**Re: RITA 10 RSSP Amendment  
Comment Response**

This letter is in response to Commissioner Makansi's request for hydraulic modeling data for the RITA 10 RSSP Amendment area. Through existing modeling, fieldwork, and the additional analysis that has been provided to the Commission, we have been able to determine that there are opportunities to consolidate flows in a way that will provide positive outcomes for both habitat and large-scale new development in Tucson, while ensuring adequate floodplain management for the overall RITA 10 area. Psomas has identified relevant regulations and researched the extent of existing floodplain studies available that have been completed for this area by Pima County Regional Flood Control District (RFCFD). Floodplain extents depicted on the attached exhibit were obtained directly from those studies. Existing studies can primarily be obtained online through the RFCFD website shown below. Psomas has attached the single study not currently available online, prepared by CMG for RFCFD as part of work being completed for two Psomas Projects: 1) South Houghton Road for the County DOT and 2) Fairgrounds Channels for RFCFD.

**DRAINAGE REPORT  
FOR  
FAIR

**Figure X**  
**Rita I-10 PAD**  
**Master Drainage Plan**  
**Concept Flow Corridors**

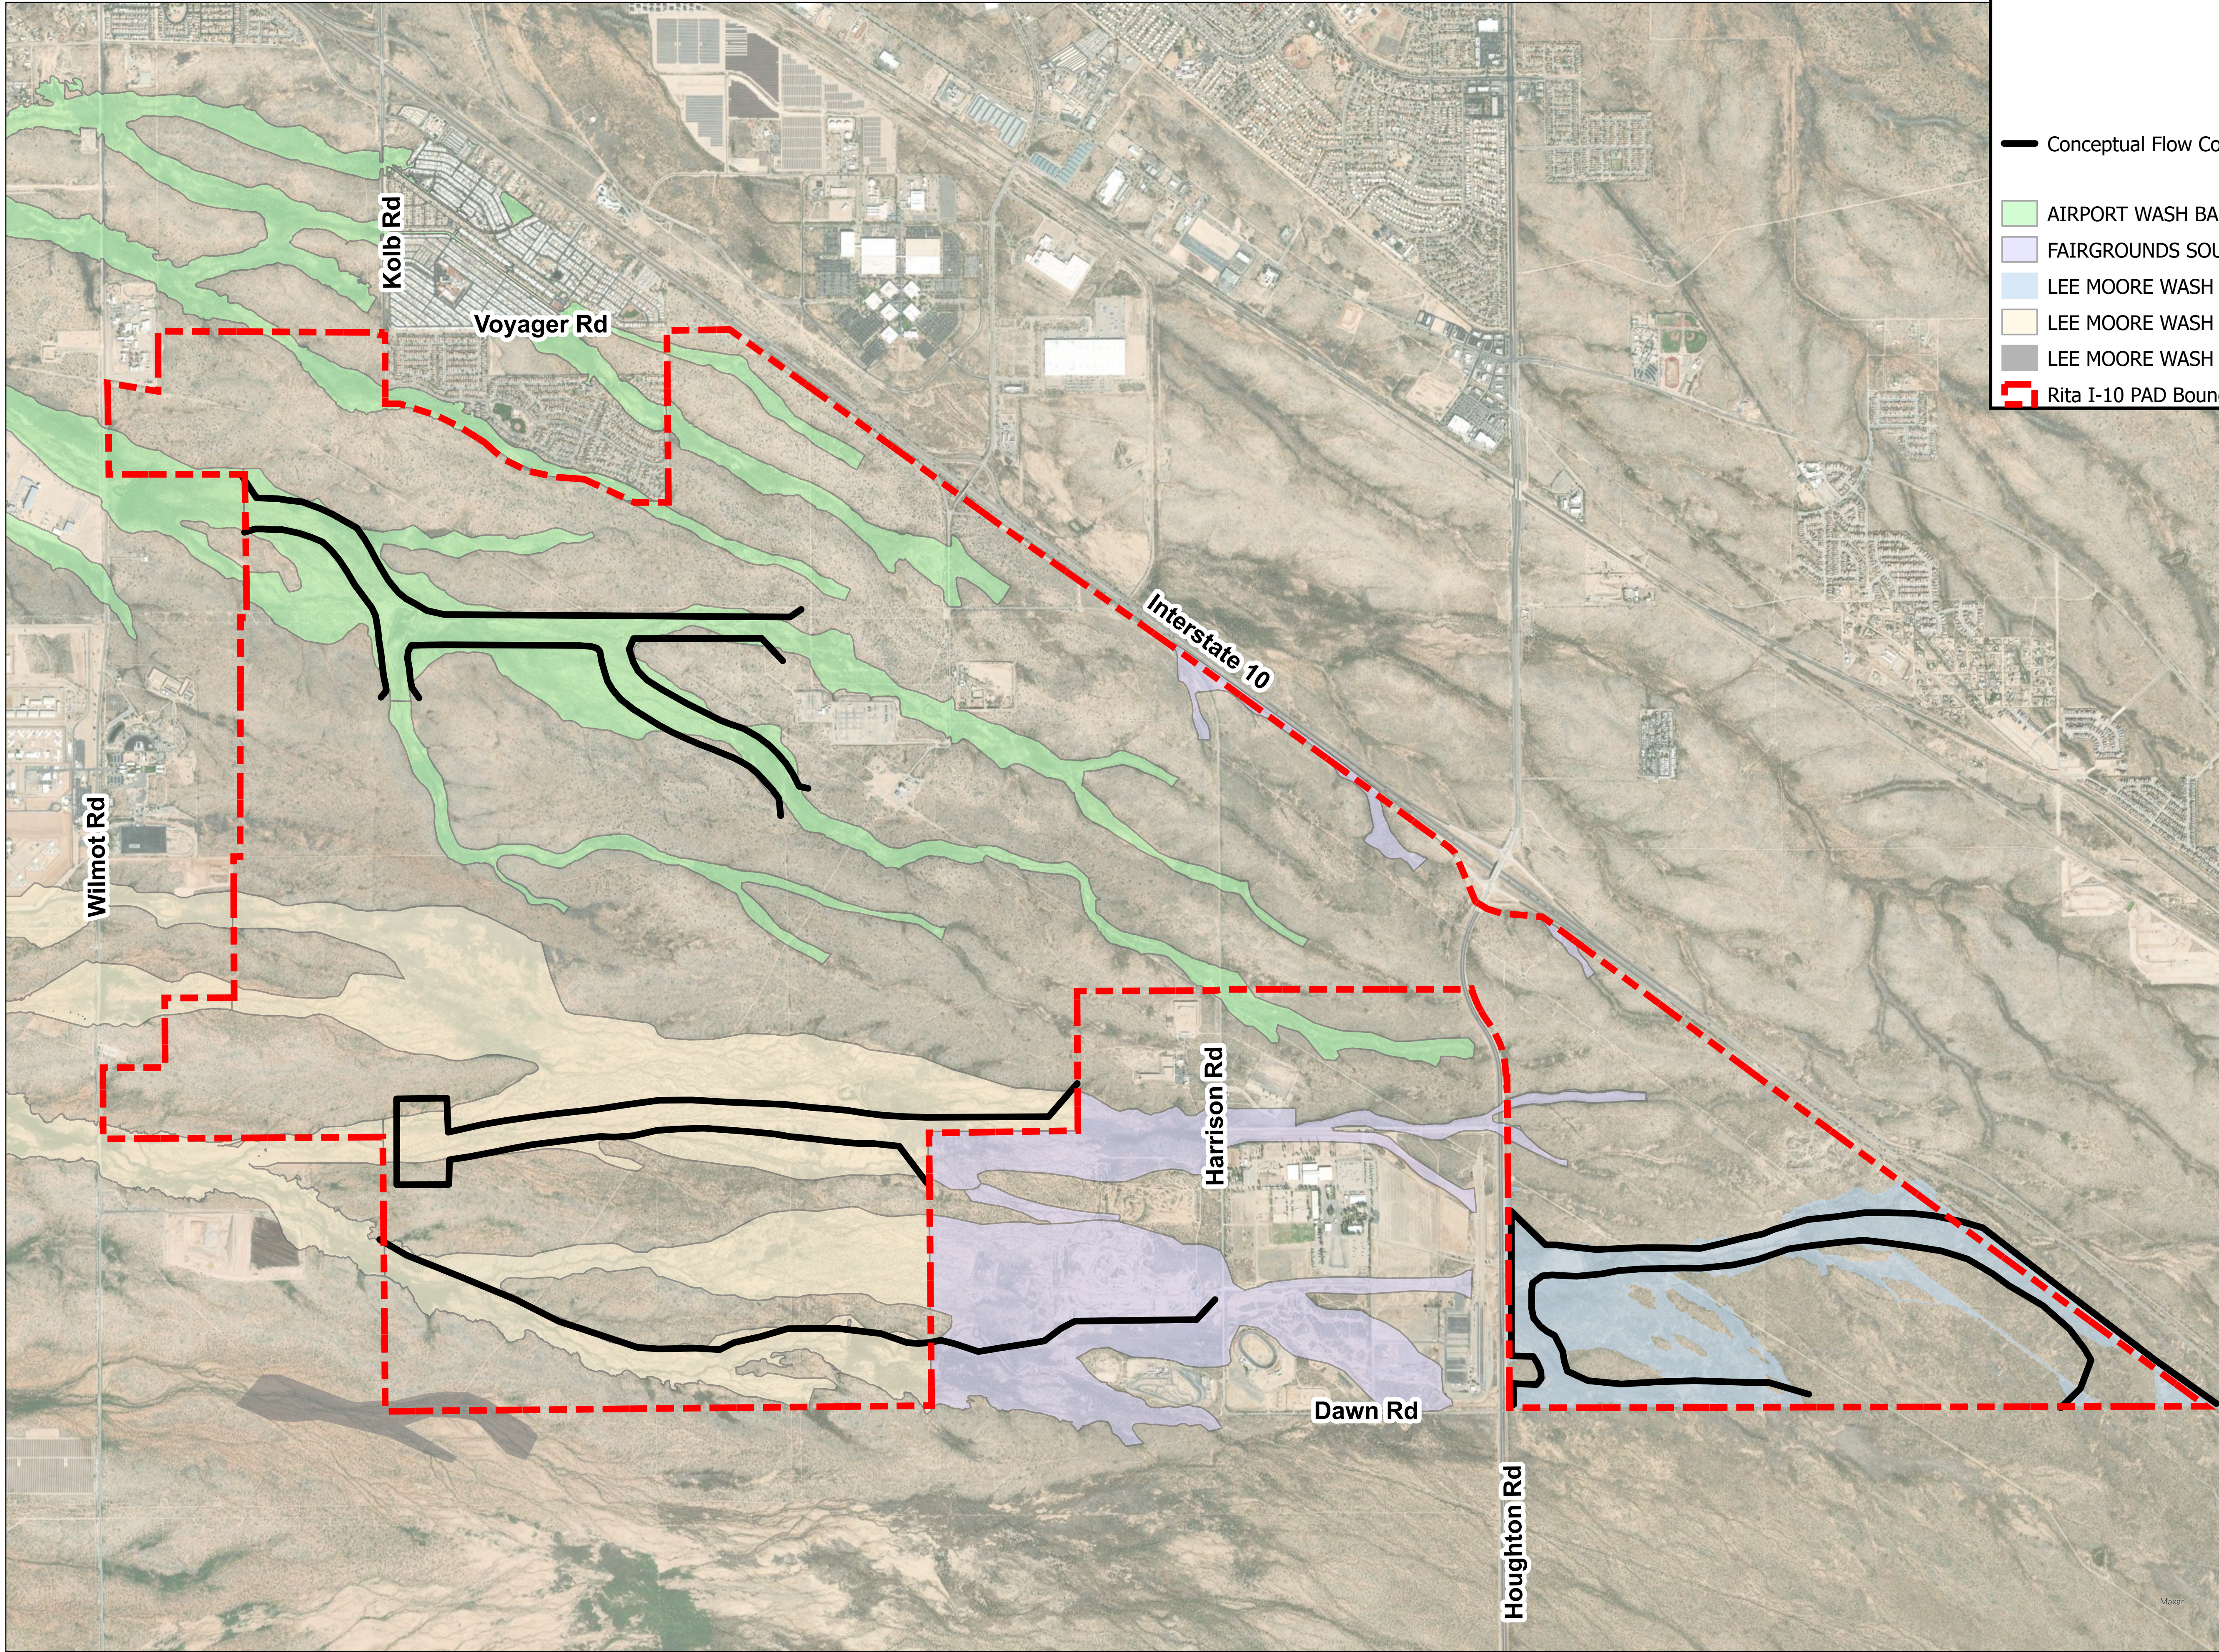
Psomas has performed a review of the existing floodplain conditions and used the accepted flow rates from the various studies to perform high-level proposed conditions evaluations to support the potential flow consolidation, tying into existing and planned consolidated channels through the Fairgrounds and SELC property to provide continuity.

Once approval of the policy amendment is obtained, ASLD or future developers will be required to complete additional studies during the PCD or secondary planning stage to identify how and where the consolidated corridors will be created.
